Site Inspection Report of Proposed 1320 MW Thermal Power Plant of Welspun Energy U.P. Private Limited At Dadri Khurd, Mirzapur

Visit Date: 15th September, 2013

Ministry of Environment and Forests,
Government of India

Vindhyan Ecology and
Natural History
Foundation

Image 1: 'Forest Land' shown as bamboo plantation in the EIA Report (outset: banner of forest department on a tree)

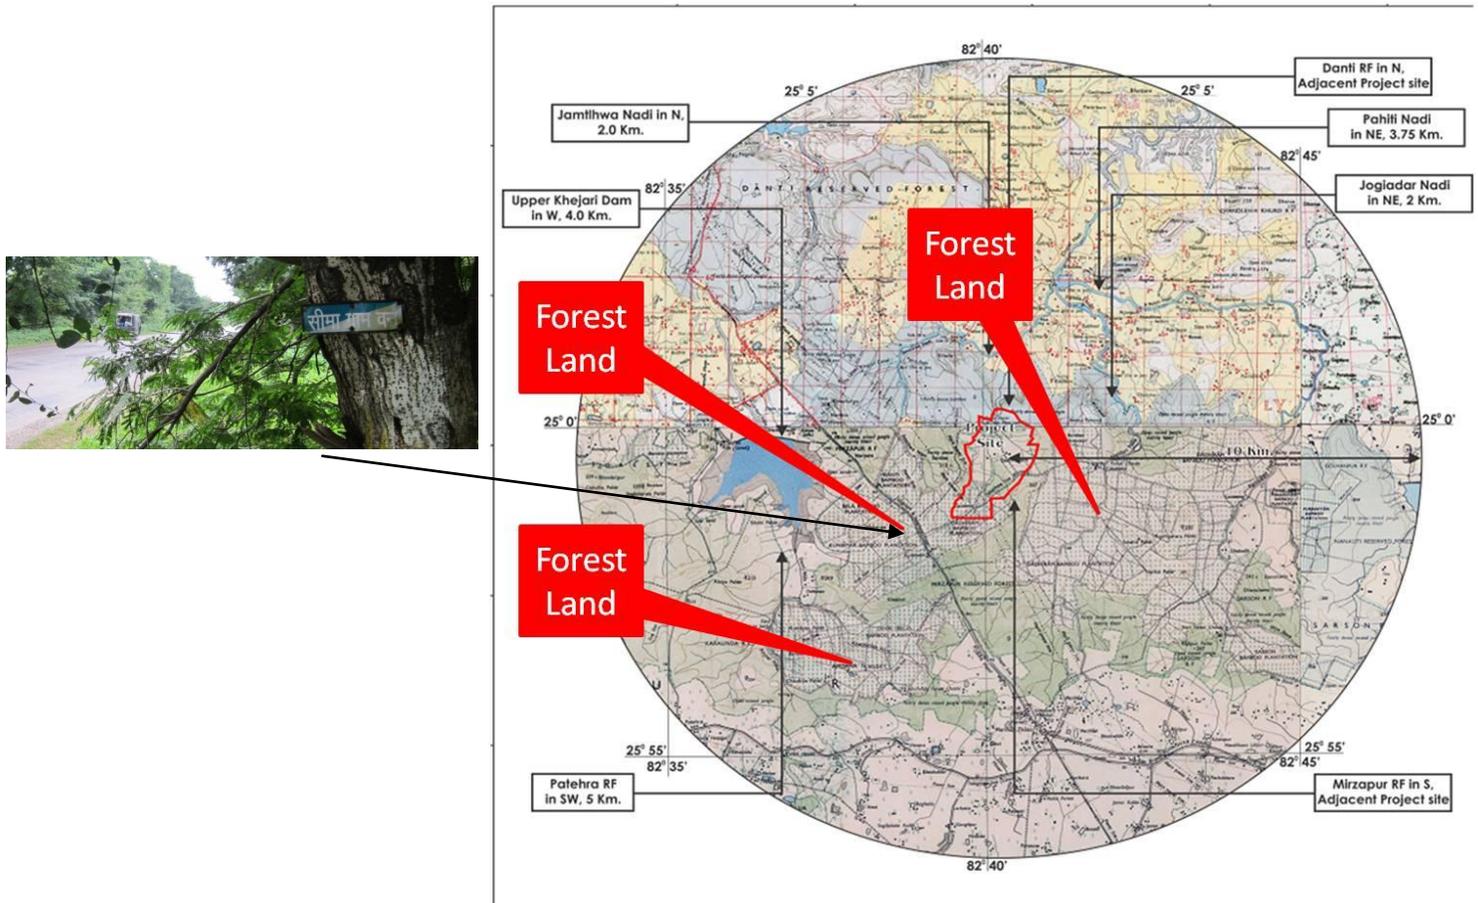
- I. There is no way one can evade forest land before reaching the place.
- II. Transfer of coal by railway lining or even construction of road cannot happen without clearing forests.

- III. The bamboo plantations shown in the EIA report also belong to Forest Department. This makes the entire region except the project site a forest area including the portion of SH-5 which has forest land on both of its side.

- IV. The proposed pipeline for pumping water from the river Ganga falls well within the forest land even though it is claimed to be motorway.
- V. The small spur claimed to be road by the project proponent was found to be part of forest land with a banner clearly showing its legal condition. The said spur through the forest land meets the gate of project site which happens to be also the immediate boundary of the Forest department. The width of the road is just 6-8 feet wide and purely a road being formed by regular passage of villagers. It is a forest road owned by Forest Department, and cannot be treated as common road. A board being put up by the Forest Department proves the fact very well.

- VI. The project area is not barren as claimed in the EIA report. There happens to be similar forest as found in the reserve forest area with good vegetation cover. It can be referred as mix forest with mixture of trees, shrubs and grasses.

Image 8: Map showing the connection of Upper Khajuri Dam, Wyndham Fall, BHU Campus and Lower Khajuri Dam.

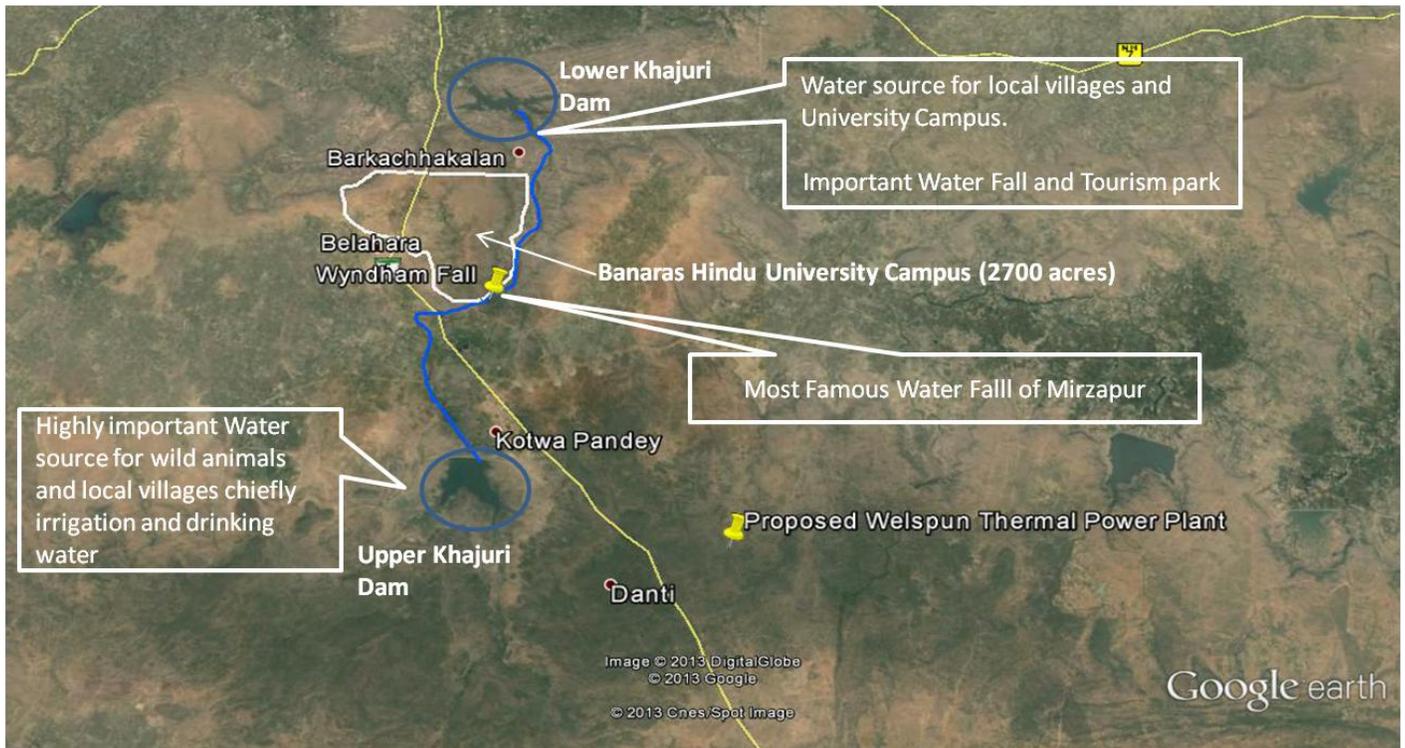
- i) Banaras Hindu University has developed its new campus spreading over area of 2700 acres with fairly good population of students and staff which is at present approximately 5,000 and bound to increase many times as it is still under development stage. It is a residential campus with hostels and all infrastructures are present in a mini-township plan. The source of water including drinking water for the campus is Lower Khajuri Dam. The water from Upper Khajuri dam flows via Khajuri River to Lower Khajuri Dam and thus any alteration to Upper Khajuri will have immediate implication on Lower Khajuri.

- ii) Wyndham Fall is the main tourist attraction not only in Mirzapur but it also attracts tourist from neighbouring districts of Varanasi, Allahabad, Bhadohi and Chandoli. The water flowing through Upper Khajuri dam to Lower Khajuri when passes through the dead end of hilly terrain it forms a beautiful water fall. The forest region surrounding the Wyndham fall is used by wild animals for foraging and hunting. Due to Wyndham Fall a large number of local people gets employment who are engaged in transportation and other facilities for tourists. The Khajuri river also serves a fishing source for local villagers who depends on the fishes for their food. Using water from Upper Khajuri will damage immensely the pride of Mirzapur. Just adjacent to Banaras Hindu University Campus, students of the university conducts maintenance cum cleanliness drive of Wyndham Fall with Forest Department every year.

The impact of this project will not be only to the local villagers who depend on Upper Khajuri Dam but it will have impact on entire region as Upper Khajuri is a source of drinking water of Banaras Hindu University
